**THE ROVER COMPANY LIMITED**  
**S E R V I C E D E P A R T M E N T**

**Rover Service News Letter No. 52**

February, 1955

**SECTION II. WORKSHOP AND SPARE PARTS INFORMATION**

Fig. 1. Layout of brake linkage.

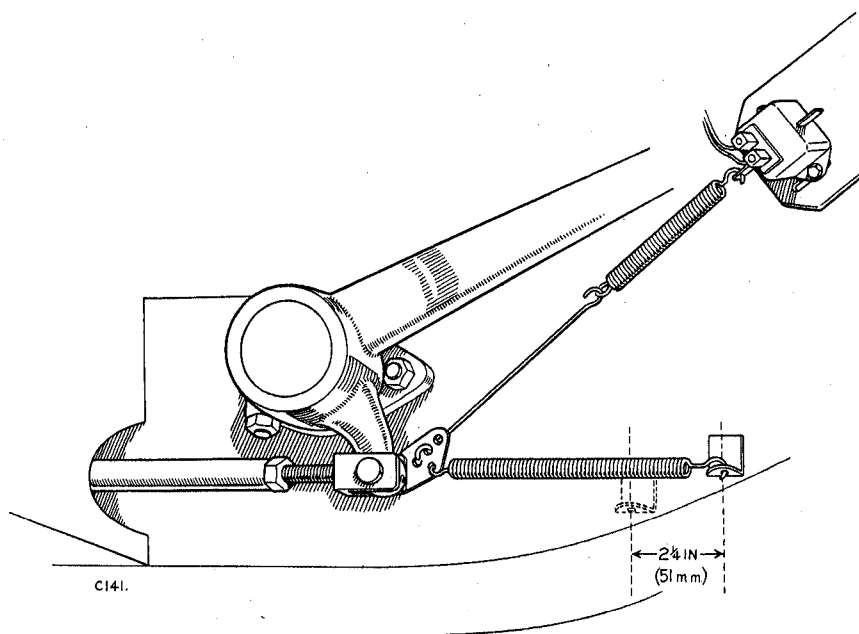
COMPLAINT: Restricted brake pedal movement

CAUSE: Due to snow lodging between body bracket and bracket for brake return spring.

CURE: Fit new parts as detailed below.

Any earlier 1954 or 1955 '60', '75' and '90' Car can be modified if so desired, by carrying out the following. See Fig. 1 below for layout of new parts.

1. Remove brake pedal return spring from chassis bracket.
2. Remove stop lamp link adjuster nipple and remove link.
3. Remove fork end joint pin.
4. Remove fork end from master cylinder connecting tube.

5. Remove spring anchor from brake tube.
6. Weld a suitable bracket to chassis side member for the brake pull-off spring. The bracket to be approximately  $2\frac{1}{4}$  in. (57 mm.) forward of the original bracket, which should be removed.

7. Refit fork end and replace joint pin.
8. Check that master cylinder has  $\frac{1}{16}$  in. (1.6 mm.) free play at the push rod and tighten locknut.

9. Fit anchor plate (266270) to joint pin for fork end and split pin, discarding the original plain washer.
10. Remove brake stop lamp switch and bracket.

11. Fit bracket for stop lamp switch (266272) using original position on wing valance. Alternatively, the holes in the original bracket can be slotted to give adjustment to the stop lamp switch link.

12. Fit stop lamp switch and connect up link (266271) using a suitable hole in the anchor bracket, adjust link by means of the stop lamp switch.

Fig. 2. Backlight from L.H. side.

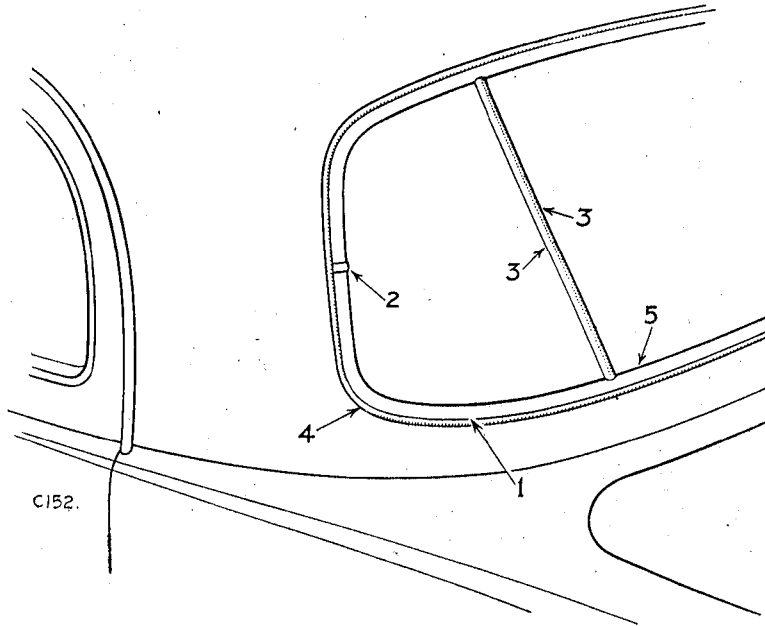
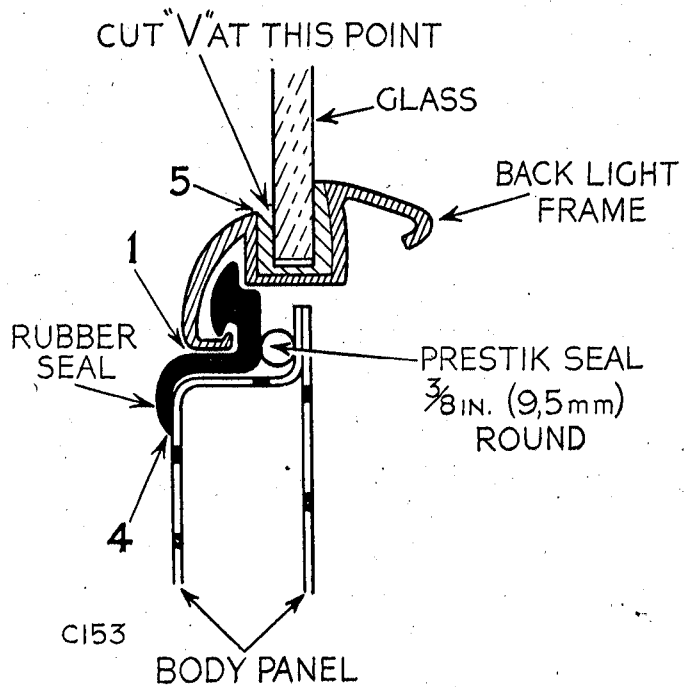
**It is most important** that any work carried out on the 1955 backlight is done **thoroughly**, even a small break in the sealing compound may allow water entry.

- (a) Using a suitable gun and nozzle inject Sealastik at the following points:—
- (1) All round the backlight between chrome bead and rubber seal. (See Figs. 2 and 3, Item 1.)
  - (2) Underneath the chrome clips at either side of the chrome beading. (See Fig. 2, Item 2.)
  - (3) Between backlight glass and vertical rubber seals. (See Fig. 2, Item 3.)
  - (4) All round backlight between rubber moulding and body. (See Figs. 2 and 3, Item 4.)
- (b) Cut a deep "V" in the rubber seal between glass and chrome bead and fill in with Sealastik. (See Figs. 2 and 3, Item 5.)

Fig. 4. Boot interior from left-hand side.

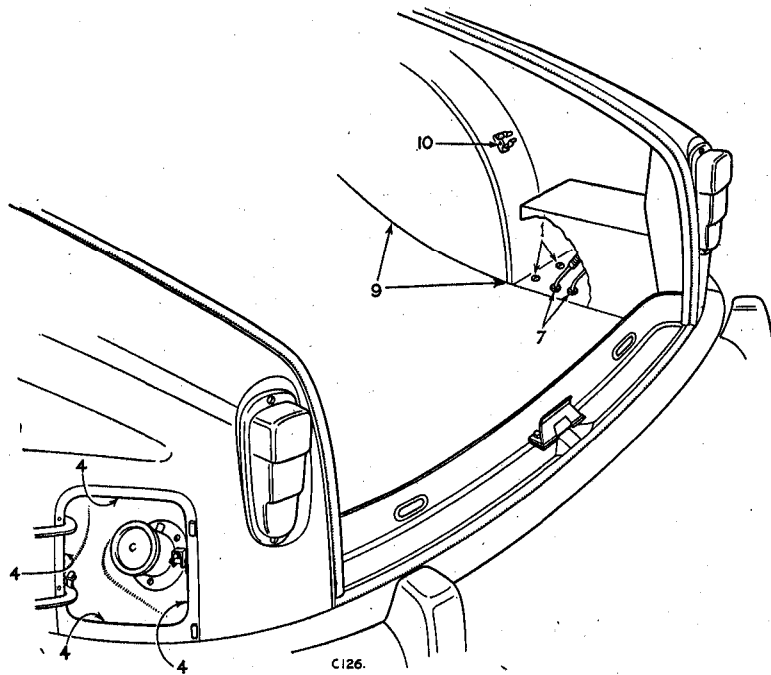
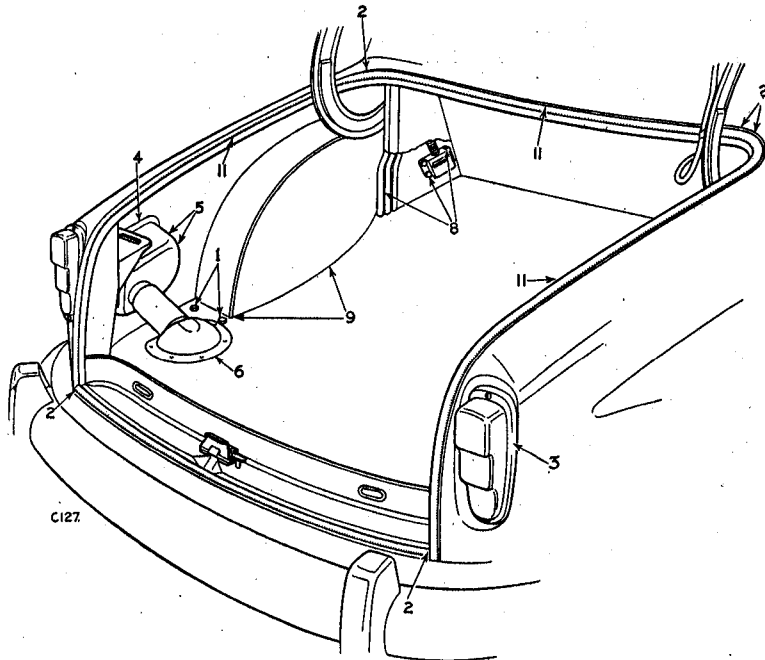
Two cage nuts immediately behind L.H. wheelarch. Two nuts and bolts immediately behind R.H. wheelarch. Seal with Bostik. (See Figs. 4 and 5, Item 1.)

The petrol filler compartment—passing round the edges of the filler lid and between the panels and thence between the panel of the boxed-in section and the adjoining inner panel of the wing. The cut away edge of the boxed-in section panel should be sealed with a suitable compound. Seal off round the edges. (See Figs. 4 and 5, Item 4.)

Between the junction of the wheelarch and the floor, seal with Bostik, especially at the corners, where the joint flange passes through the floor. (See Figs. 4 and 5, Item 9.)

The rubber surrounding the boot lid aperture and engaging the face of the lid may allow water to pass the guttering.

At the bottom of the gutters, and also through the welding at the top corners of the main boot lid sealing rubbers. Seal with Bostik where necessary. (See Fig. 5, Item 2.)

The body of the tail lamp, i.e., by-passing between the rubber seal and the wing panel. (See Fig. 5, Item 3.)

The slots in the body, for the bolts holding the petrol filler lid hinge. Seal with Prestik washers. (See Fig. 5, Item 5.)

The flanges of the petrol filler neck where it adjoins the floor of the boot and petrol filler compartment. Seal off the edges with a suitable compound. See Fig. 5, Item 6.)

Four bolts in each wheelarch, holding the boot lid hinge support and three holding the trunnion bracket. Seal with Prestik washers. (See Fig. 5, Item 8.)

Remove the sealing rubber. Inject Sealastik all round the guttering, refit rubber and manipulate the rubber so that the lip protrudes above the wing line. (See Fig. 5, Item 11.)

Remove the complete lamp and use a suitable compound to seal the rubber seal and wing. Seal between rubber and lamp bezel with Prestik. When replacing the lamp, do not tighten the nuts excessively, as this will distort the rubber seal.

Fig. 6. Front door pillar, left-hand side.

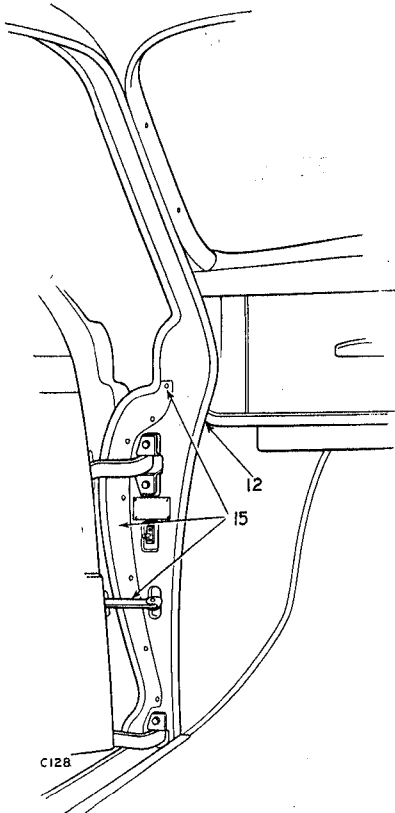
The sealing of the rubber retaining plates on the 'A' post should be checked from the top to the level of the door check straps; add sealing compound where necessary. (See Fig. 6, Item 15.)

Fig. 7. Scuttle, left-hand side.

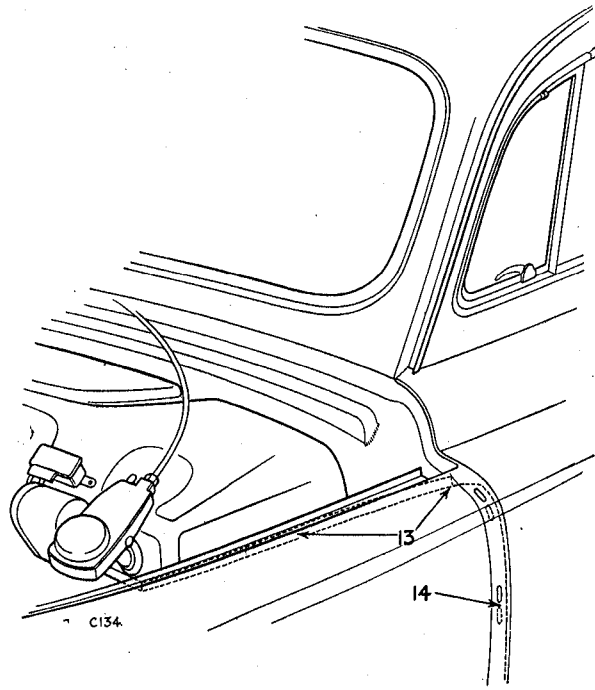
The spot welded seam, and the joint between the seam and the rear face of the 'A' post. Paint over with Bostik as necessary. (See Fig. 7, Item 13.) The angle for attaching the wing is bolted to the side of the dash by four set bolts. The slotted holes in the scuttle should be sealed with Prestik washers with 1½ in. (48 mm.) diameter aluminium washers on top; both being under the angle. (See Fig. 7, Item 14.)
